REV.  
B

BOLT, MACHINE, HEXAGON HEAD, DRILLED, 6 HOLE, PD SHANK, STEEL AMS6322 (UNS G87400), CADMIUM PLATED, .6250-18 UNJF-3A

AS9964™  
SHEET 1 OF 3

FIGURE 1 - BOLT

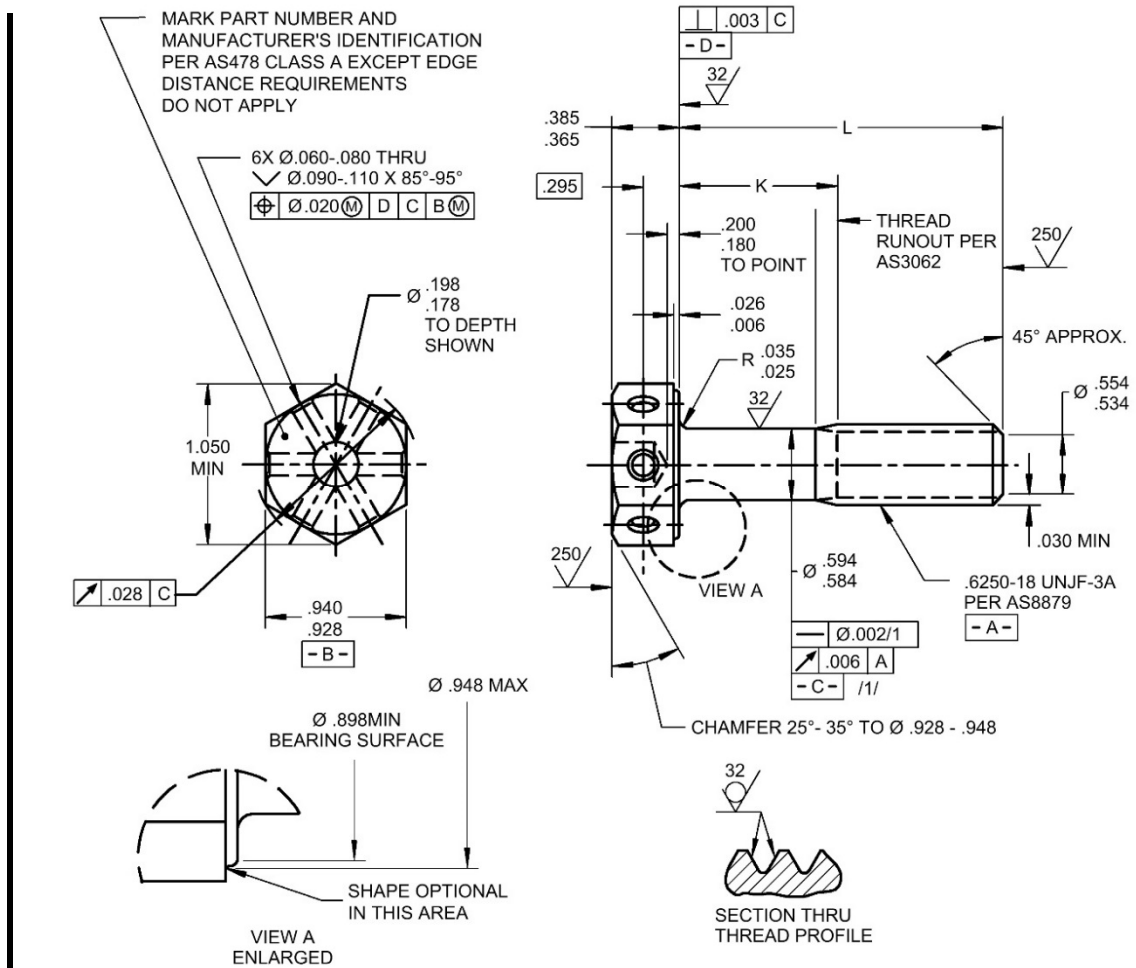
FIGURE 1 REDRAWN, RESTORE DATUM D (INADVERTANTLY DELETED ON LAST REVISION), CORRECT ERROR IN HEAD THICKNESS CALLOUT IN FIGURE 1 (PER ORIGINAL ISSUE), CORRECT ERROR IN L DIM FOR P/N MS9964-07, ADD TERTIARY DATUM TO FEATURE CONTROL FRAME FOR DRILLED HOLES, REVISE LEAD THREAD CHAMFER, CLARIFY NOTE 3 AND DELETE DUPLICATE REQUIREMENT REFERENCES, UPDATE MPI REFERENCE, ADD NEW NOTE FOR DISPOSITION OF EXISTING INVENTORY, UPDATE DRAWING FORMATS TO ANSI Y14.5M-1982, ADD AS3062 FOR THREAD RUNOUT, ADD EDGE DISTANCE EXCEPTION FOR MARKING, GENERAL EDITORIAL UPDATES.
